**ADDENDUM No. 1
DOCUMENT 00 91 13-A**

**PROJECT: RENOVATION OF DISTRICT 1 WELCOME CENTERS, IN
ALCORN & ITAWAMBA COUNTIES**

**PROJECT NUMBER: BWO-1182-02(002) / 503757-301000
BWO-1181-29(004) / 503757-302000**

**ALCORN CO.
 WELCOME CENTER
 BUILDING**

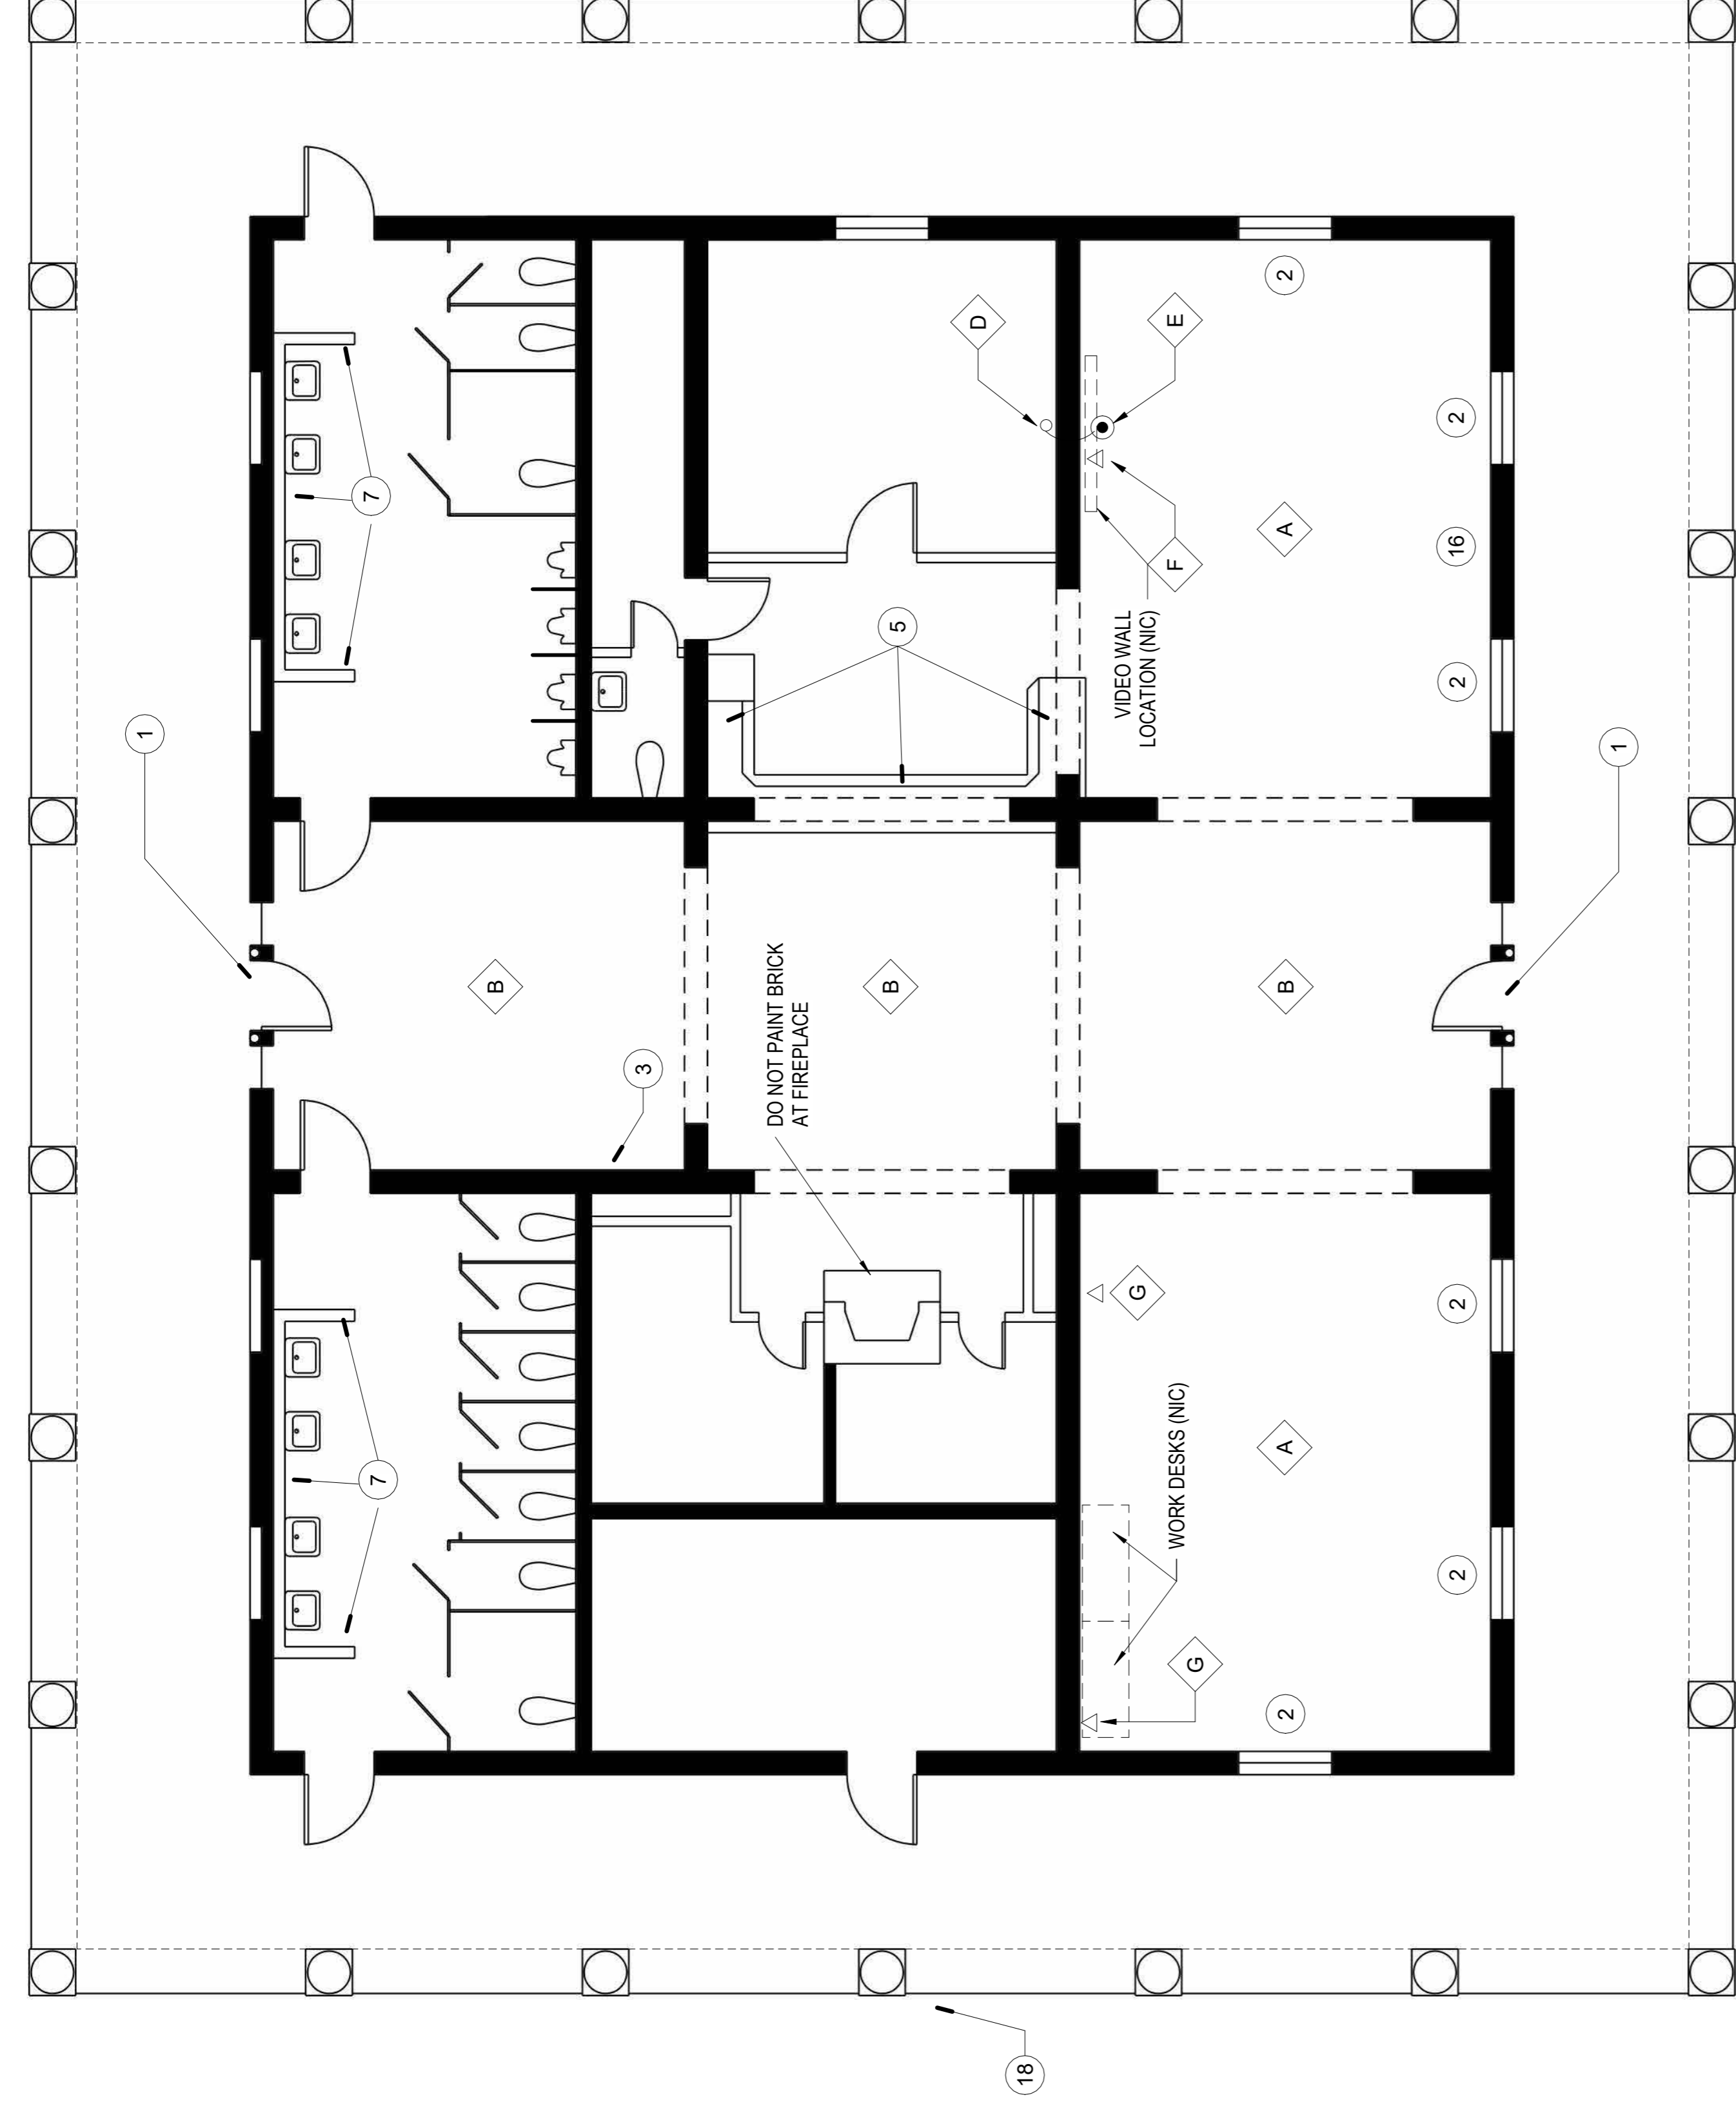
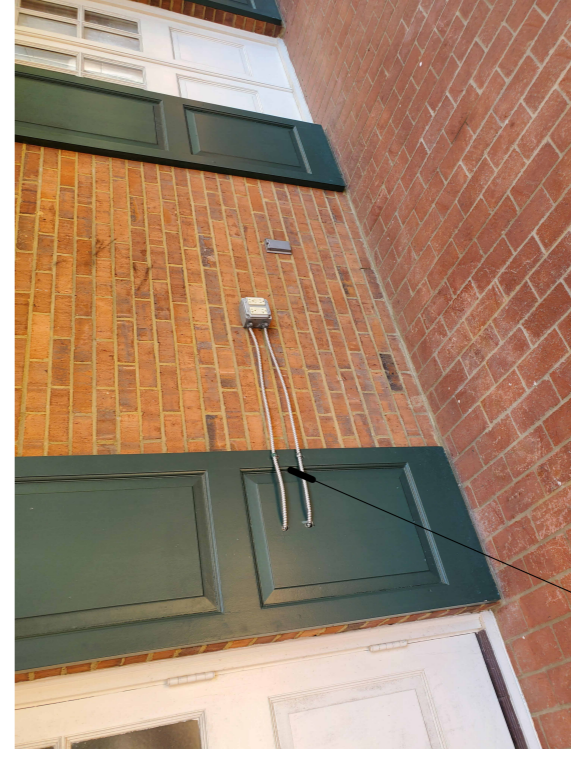
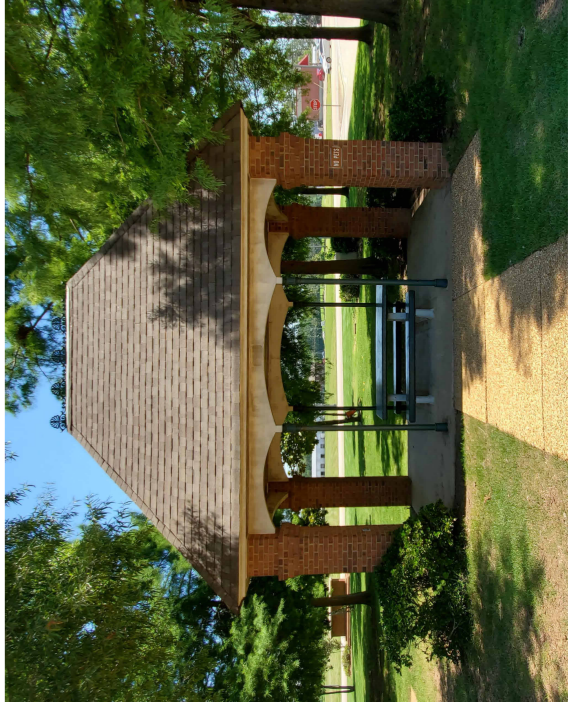
- A. Added Sheet No. 1 – Sheet Index
- B. Sheet No. 2, Alcorn Notes 1,6,7,13 revised 10-4-24, see revisions.
- C. Sheet No. 2, Alcorn Notes – Note 18 – delete the existing note and replace with **“Install two (2) pet waste stations, to be supplied by Owner. Dig a post hole 24 inches deep, install post in concrete, install waste can on post, 6 inches off ground, install dispenser and sign on post. Follow the manufacturer's installation instructions.**
- D. Sheet No. 3, Itawamba Notes 1,4,7 revised 10-4-24, see revisions.
- E. Sheet No. 3, Itawamba Notes – Note 15 – delete the existing note and replace with **“Install two (2) pet waste stations, to be supplied by Owner. Dig a post hole 24 inches deep, install post in concrete, install waste can on post, 6 inches off ground, install dispenser and sign on post. Follow the manufacturer's installation instructions.**

- 1 REMOVE EXISTING DOOR AND REPLACE WITH NEW FIBERGLASS DOOR AND HARDWARE. VERIFY SIZE AND HEIGHT. SEE SPECIFICATION.
- 2 REMOVE SURFACE MOUNTED ELECTRICAL

- 6 REPLACE THREE (3) HAND DRYERS AND STAINLESS STEEL BACKING PLATE (PER RESTROOM) WITH BRADLEY MODEL 2923-28W001 OR APPROVED EQUAL.
- 7 REFINISH ALL EXISTING STAINED WOOD DOORS. REMOVE HARDWARE. CLEAN, AND REUSE. SAND, STAIN, AND APPLY POLYURETHANE FINISH. SEE PAINT SPECIFICATION. REINSTALL DOOR AND HARDWARE.

- 13 PAINT ALL EXISTING PAINTED WOOD DOORS AND EXISTING FIBERGLASS DOORS. REMOVE HARDWARE, CLEAN, AND REUSE. SAND, PRIME, AND PAINT. SEE PAINT SPECIFICATION. REINSTALL DOOR AND HARDWARE.

- 17 INSTALL NEW LITERATURE RACKS AS DIRECTED. (OWNER FURNISHED)
- 18 INSTALL PETWAY STATIONS AS DIRECTED. (OWNER FURNISHED)
- 19 REMOVE EXISTING WALL MOUNTED TV AND MOUNT AS DIRECTED. REMOVE UNUSED SURFACE MOUNTED TV CABLES AS DIRECTED. PATCH HOLES PRIOR TO PAINTING.
